36 Station Road, Hayling Island

Design and Access Statement

This application seeks consent to demolish existing buildings (shop, 1no. flat, workshop, associated compound and 2no. dwelling houses) to allow construction of 18no. new build flats and shop use (planning class A1) with associated bin store, cycle store, vehicle parking and landscaping at 36 Station Road, Hayling Island, Hampshire, PO11 0EQ

First pre-planning application, design comments received March 2015

Standing level perspective from the junction of Station Road and West Lane, facing north

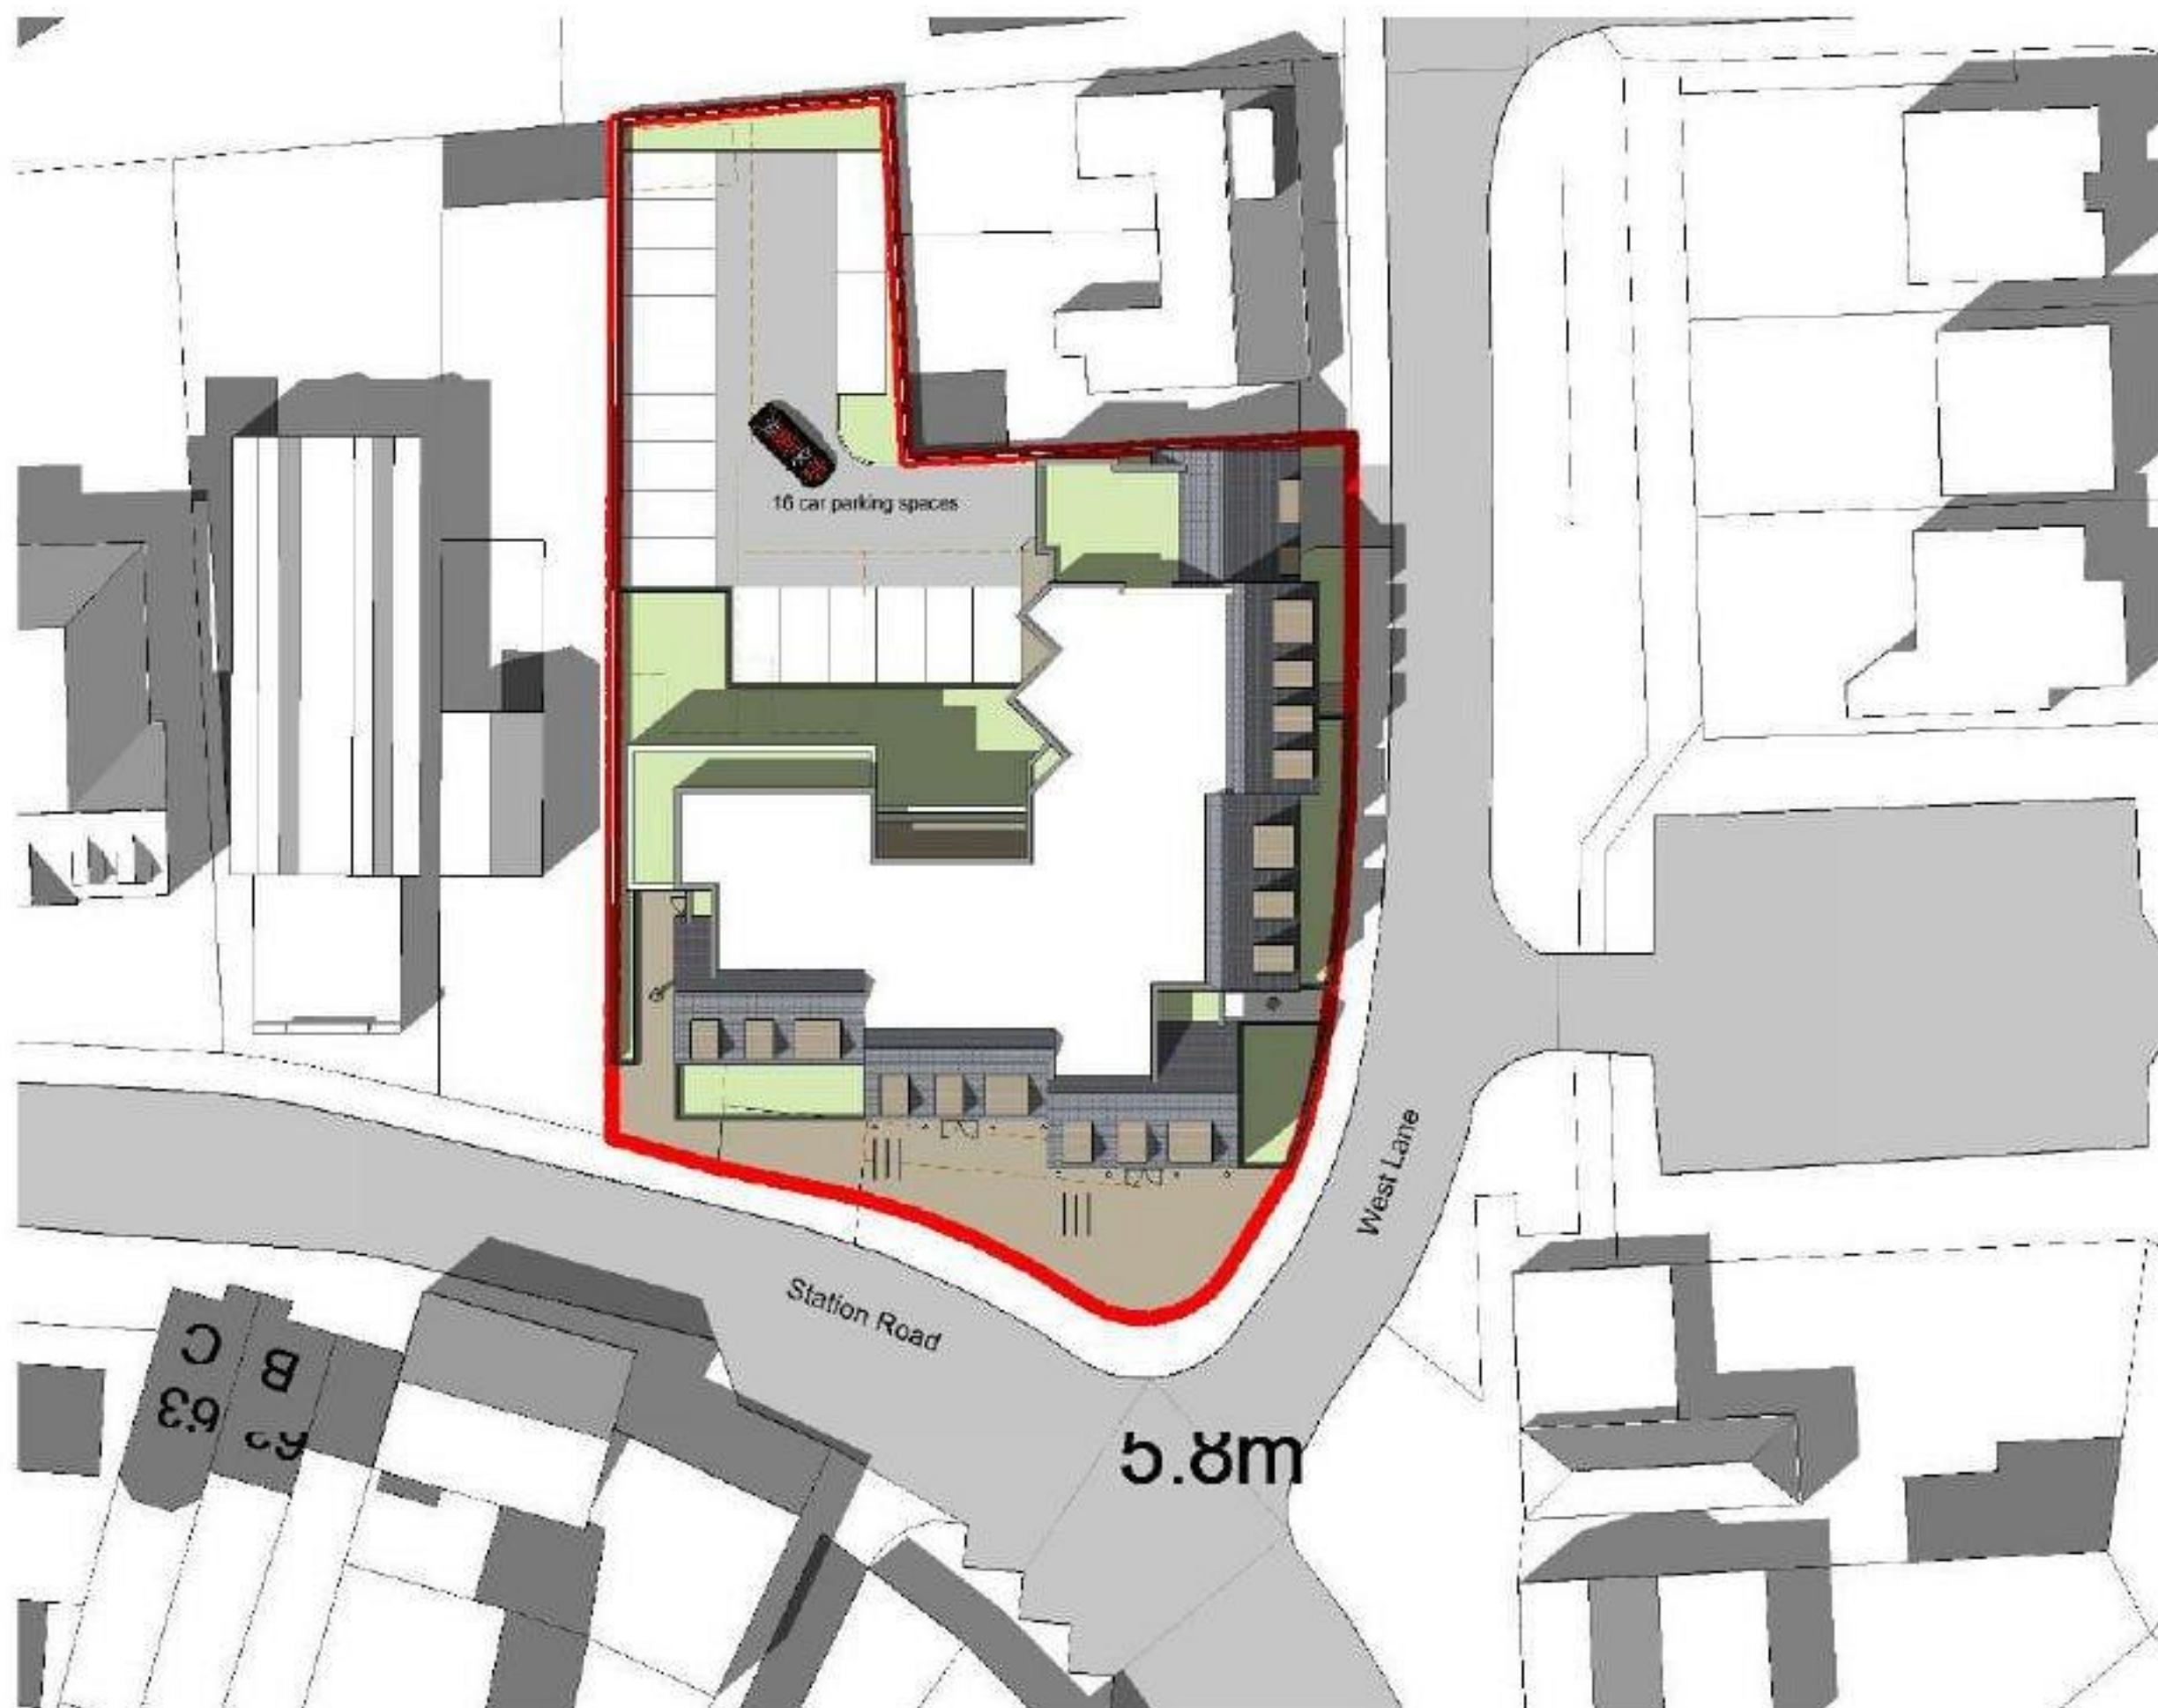
- The redevelopment potential was commented as being a great opportunity for high quality landmark development to strengthen the character of the area.

- Redevelopment poses an opportunity to simplify the public realm and find another solution to the control of access, which currently relies on bollards.

- Footprint of the building is to carefully consider the set back neighbouring buildings.
- Single design approach discouraged, as this blurs the character of the two streets.

- Local precedent for shops are that they are hard up against site frontages.
- Avoid the use of planters.
- West Lane is informal in character compared to Station Road.

- Corner offers potential for a strong eye-catching landmark
- Suggested to push the eastern elevation back and provide small front garden space.
- Blank gable ends not encouraged.

- Lighter colour palette to materials recommended.
- The principle of the development was supported.
- Justification required to the number of parking spaces provided if more could not be provided.

- More cycle parking to be provided.
- Stated it would be important to retain the same amount of commercial space as currently available.
- Suggested that the full frontage to Station Road be designed as the commercial element.

- Requested flats are increased in size to meet guidance (1-bed 45-50sqm, 2-bed 57-67sqm).

First pre-planning application, comments received March 2015

The proposed design has been developed to address comments raised from the above pre-planning application, as summarised below:

- Footprint adjusted, pulling in from the road on both elevations to lessen any potential impact on neighbouring buildings.
- Dual design approach, to distinguish between the two streets. Less formal approach taken for the West Lane facing elevation.
- No planting to the front of shops.
- No planters proposed.
- Feature corner proposed.
- Front garden space provided to eastern ground floor flats.
- No blank gables proposed.
- Lighter colour palette proposed.
- More cycle parking proposed.
- Commercial element retained and increased in size, resulting in a wider frontage to Station Road.
- Flat sizes increased to meet guidance.
